SUNLIGHT INSPECTION SERVICE

125 New Home Rd Lot 34 Phoenixville, PA 19460

REPORT# 23021204D

The following numbered and attached pages are your pre-drywall inspection report. The report includes photographs, comments, and the Standards of Practice. This inspection was performed in accordance with the current Standards of Practice for Residential Pre-drywall Inspections of the American Society of Home Inspectors. The Standards contain certain and very important limitations, exceptions, and exclusions to the inspection. A copy is available prior to, during, and after the inspection, and it is part of the report. All components designated in the ASHI standards of practices, except for limitations that may be noted in the report, will be inspected. The inspection is for the most part a limited visual inspection only. A representative sampling of the building components is viewed in areas that are accessible at the time of the inspection. No destructive testing or dismantling of components is performed. Be sure to keep your signed copy of the home inspection agreement along with the report for future reference.

METAL ROOF

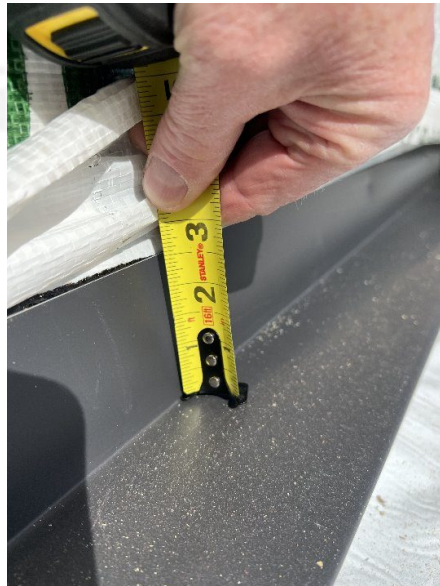
The side wall flashing for the metal roof does not extend far enough up the wall. Sidewall flashing should extend up the exterior wall a minimum of 4 inches.

The sidewall flashing is less than 3 inches high. This will be an issue when installing the Hardi plank siding. Hardi plank siding requires 2 inches of clearance from the bottom of the siding to the roofing material. This will leave less than an inch of coverage over the top edge of the flashing.

R Code Reference**R905.2.8.3 Sidewall flashing.**

Flashing against a vertical sidewall shall be by the step-flashing and shall be not less than 4 inches in height of 4 inches in width and shall direct water away from the vertical sidewall into the roof or onto the gutter. Where siding is provided on the vertical sidewall, the vertical leg of the flashing shall be continuous under the siding. Where anchored masonry veneer is provided on the vertical sidewall, the base flashing shall be provided in accordance with this section and counter flashings shall be provided in accordance with section R703.8.2.2. Where exterior plaster or adhered masonry veneer is provided on the vertical sidewall, the base flashing shall be provided in accordance with this section and are 703.6.3

Foundation Anchor Locations

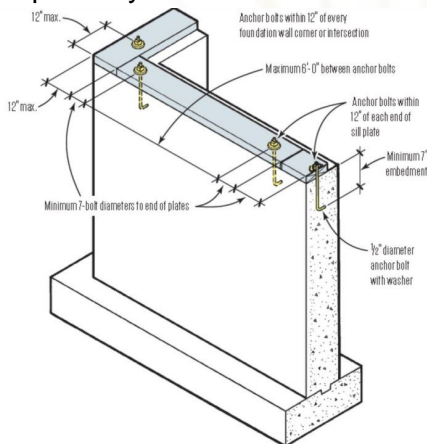
C Missing foundation bolts were noted. Foundation bolts without nuts and washers on them were noted. Bent and damaged foundation bolts were noted.

Five foundation bolts in the garage were noted without washers and nuts on them. In the basement above the left foundation wall, four foundation bolts are missing and three foundation bolts are damaged.

The bottom sill plate of each exterior wall should be anchored to the top of the foundation wall with 1/2 inch bolts. There should be a bolt within 6 inches of the end of each sill plate and the bolts are 6 ft on center. Each bolt should have a washer and a nut on it.

Wood sole plates at all exterior walls on monolithic slabs, wood sole plates of braced wall panels at building interiors on monolithic slabs and all wood sill plates shall be anchored to the foundation with 1/2 inch diameter anchor bolts spaced not greater than 6 feet on center or approved anchors or anchorage straps spaced as required to provide equivalent anchorage to 1/2 inch diameter anchor bolts. bolts shall extend not less than 7 inches into concrete or grouted cells of concrete masonry units. The bolts shall be located in the middle third of the width of the plate. A nut and washer shall be tightened on each anchor bolt. There shall be not fewer than two bolts per plate section with one bolt located not more than 12 inches or less than seven bolt diameters from each end of the plate section. Interior bearing wall sole plates on monolithic slab foundations that are not part of a braced wall panel shall be positively anchored with approved fasteners. Sill plates and sole plates shall be protected against decay and termites where required by section R317 and R318

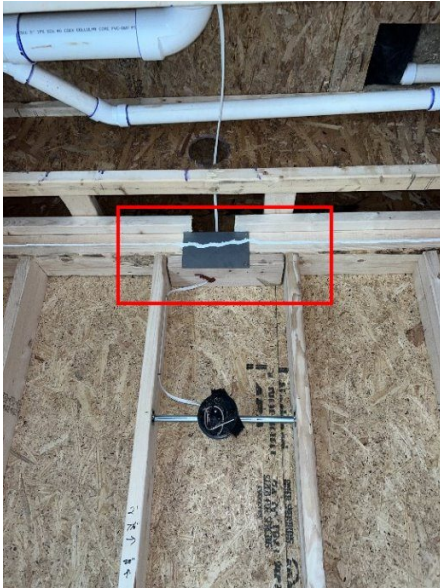
C A top plate that has been cut all the way through was noted in the back left first-floor bathroom wall. When the top plate of a loadbearing wall has been cut more than 50% to allow access for pipes, wires or ducts a metal tie must be installed to add structural support to the wall. The strap must extend 6 inches past the opening on both sides and have eight 10d nails installed on each side.

metal plate in wooden block are not
inadequate repair

basement bathroom wall

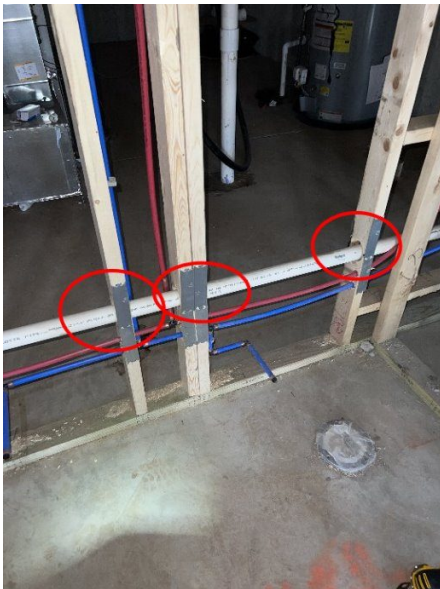
C Improper bored holes were noted in the basement bathroom and second-floor center bathroom. The holes exceed 60% of the stud width that are closer than 5/8 of an inch to the edge of the stud. Bored holes in studs of interior nonbearing walls may not exceed 60% of the stud depth and may not be within 5/8 of the stud edge. The hole may not be located in the same section as a cut or notch.

2. Drilling. Any stud shall be permitted to be bored or drilled, provided that the diameter of the resulting hole is no more than 60 percent of the stud width, the edge of the hole is no more than 5/8 inch (16 mm) to the edge of the stud, and the hole is not located in the same section as a cut or notch. Studs located in exterior walls or bearing partitions drilled over 40 percent and up to 60 percent shall also be doubled with no more than two successive doubled studs bored. See Figures R602.6(1) and R602.6(2).

second floor right bathroom

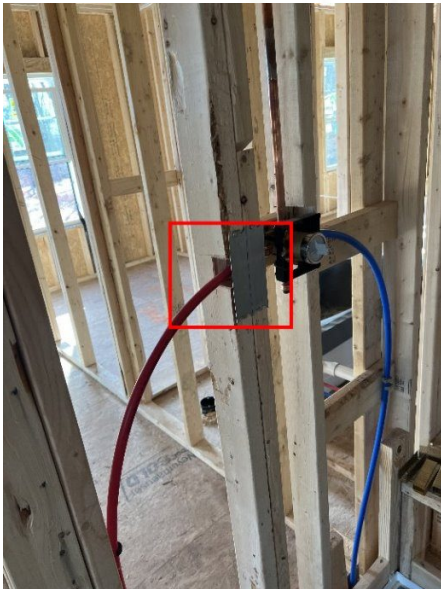
C Over notched stud was noted near the shower in the second-floor right bathroom wall. Studs in nonbearing interior walls may not be cut or notched more than 40% of their width.

1. Notching. Any stud in an exterior wall or bearing partition may be cut or notched to a depth not exceeding 25 percent of its width. Studs in nonbearing partitions shall be permitted to be notched to a depth not to exceed 40 percent of a single stud width.

Rear wall of the garage

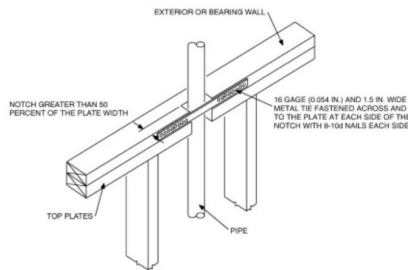
C missing metal ties were noted in the top plates of the two rear interior walls that separate the garage from the living space. Both these walls are loadbearing walls. When the top plate of a loadbearing wall has been cut more than 50% to allow access for pipes, wires or ducts a metal tie must be installed to add structural support to the wall. The strap must extend 6 inches past the opening on both sides and have eight 10d nails installed on each side. The metal shields that are in place are not adequate.

Steel plate not adequate

When piping or ductwork is placed in or partly in an exterior wall or interior loadbearing wall, necessitating cutting, drilling and notching of the top plate by more than 50% of its width, a galvanized metal tie not less than 0.054 inch thick and 1 1/2 inches wide shall be fastened across and to the plate at each side of the opening with not less than eight 10d nails having a minimum length of 1 1/2 inches at each side or equivalent. The metal tie must extend a minimum of 6 inches past the opening.

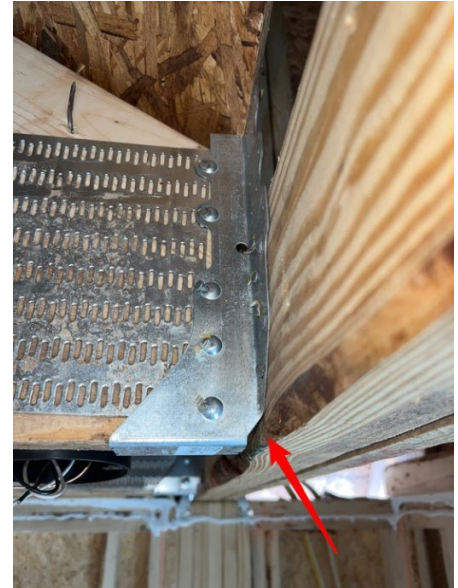
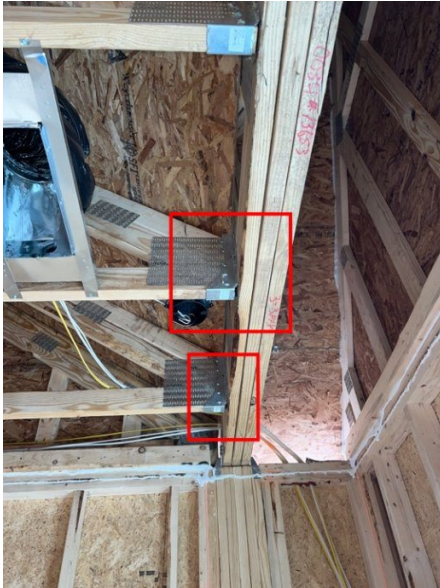
C Gaps were noted between all the ends of the roof trusses and the girder in the front right bedroom. Gaps between the trusses and the girder should not exceed 1/8 of an inch. When gaps exceed 1/8 of an inch the capacity of the connection is reduced.

The truss manufacturer should be consulted to determine if corrective action is needed.

In all cases involving a gap between the end of the carry trusts in the girder that exceed 1/8 of an inch the truss manufacturer should be notified to ensure that the truss is not adversely affected by the gap. In addition all field remedies and repairs for gaps must be designed and approved by the trusts designer or another design professional.
